Subject: Micrologix X.0 A, P & H Trip Systems in Masterpact NT & NW Circuit Breakers
A trip unit date codes: April 2001 – December 2005
P & H trip unit date codes: June 2003 -- December 2005

**PRODUCT UPDATE NOTICE
ADVISING OF POSSIBLE NUISANCE TRIP CONDITION**

Subject: Masterpact NW Drawout Circuit Breaker not utilizing the cell key bracket – all amperages and interruption ratings built to the UL and ANSI Standards, manufactured from October 1, 1999 through October 31, 2005 (Date codes 99391 – 05441 inclusive).

URGENT PRODUCT SAFETY NOTICE
WARNING OF POSSIBLE UNSAFE CONDITION

Illustration 1 (Shutter Actuator Nut Location on Circuit Breaker)

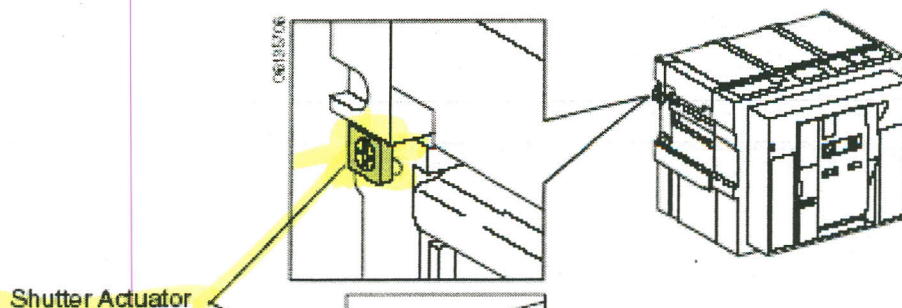
The Masterpact NW drawout circuit breaker built to the UL and ANSI standard (not utilizing the cell key bracket) may have a shutter actuator nut with the tightening torque below specification. (See Illustration 1 below for location of shutter actuator nut on circuit breaker.)

If the shutter nut torque is below specification, when the Masterpact NW circuit breaker is racked from the connected to the test position the shutter nut actuator assembly may fall from the circuit breaker. If the main disconnects (clusters) are energized and the shutter actuator nut assembly falls from the circuit breaker there is a potential for a fault to occur behind the circuit breaker in the cell. This will result in the potential for **SERIOUS PERSONAL INJURY, PROPERTY DAMAGE OR DEATH.**

Illustration 4 (Shutter Actuator Assembly)

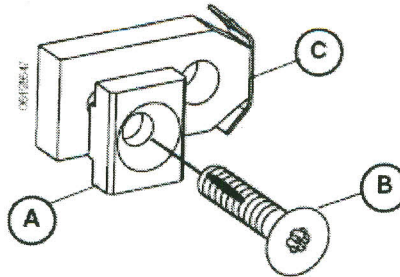
4. For UL and ANSI Standards Masterpact NW circuit breakers manufactured between **October 1, 1999** and **October 31, 2005** (Date codes 99391 – 05441 inclusive), that do not have a cell key plate installed it has been determined that replacement of the shutter actuator plate will be required.

5. A replacement kit with a new shutter actuator plate and 10-32 screw will be provided (see illustration 4). The kit part number is 64178.
